APPLICATION NO.	FILING DATE	FIRST NAMED INVENTOR	ATTORNEY DOCKET NO.	CONFIRMATION NO.
10/049,313	02/12/2002	Shingo Kawasaki	500.41132 X00	3717

Office Action Summary	Application No.	Applicant(s)	
	10/049,313	KAWASAKI ET AL.	
	Examiner	Art Unit	
	John F. Ramirez	3737

DETAILED ACTION

Fig. 1

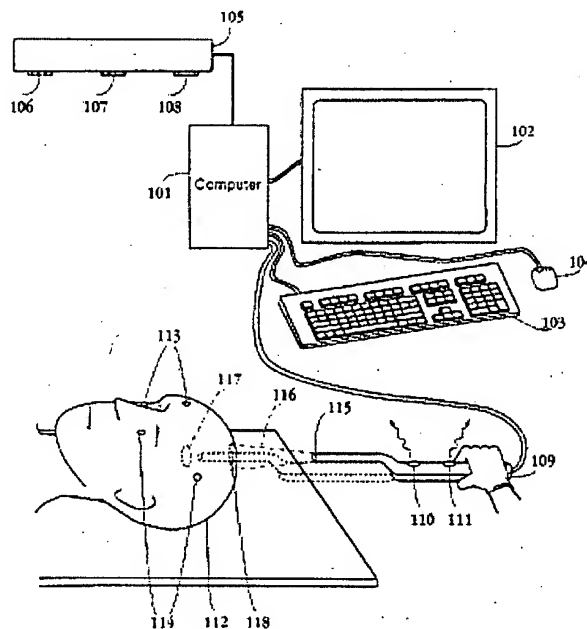
Claims 1-7 are rejected under 35 U.S.C. 102(b) as being anticipated by Shahidi (US 6,591,130).

The Shahidi patent shows in Figure 1 a biological light measuring instrument comprising means for irradiating light beams (elements 110, 111) from a plurality light

irradiation positions to a subject (Fig. 1, element 109), light detection (element 105) means for detecting light beams irradiated from said plurality of light irradiation positions and passing through the inside of said subject at a plurality of detection positions arranged near positions (see column 5, lines 51-59), and signal processing means for preparing topographic image representing ecological information about inside of said subject by using quantities of light detected by said light detection means at the individual detection positions (column 5, line 60 - column 6, line 12), said signal processing means including: means for setting three-dimensional coordinate data indicative of the positional relation between said light irradiation and light detection positions and reference points set on said subject (see Fig. 8); means for preparing three-dimensional topographic image on the basis of said three-dimensional coordinate data; and relation detection light on said subject (see Fig. 10); means for synthesizing said three-dimensional coordinate data indicative of the positional relation between said light irradiation and light detection positions and three-dimensional coordinate data of a three-dimensional morphological image of said subject to prepare and display a synthetic image of said three-dimensional topographic image and said morphological image (see Fig. 8, steps 808-811), wherein said signal processing further includes means for arranging said three-dimensional topographic image inside said subject at a predetermined depth from the surface of said subject in said three-dimensional morphological image (see column 3, line 52-60), further comprising means for inputting three-dimensional morphological image data of said subject (see Figs. 9 and 10), wherein said morphological image according includes tomographic image, wherein said

morphological image includes a CT image, wherein said morphological image includes a MRI image (see abstract).
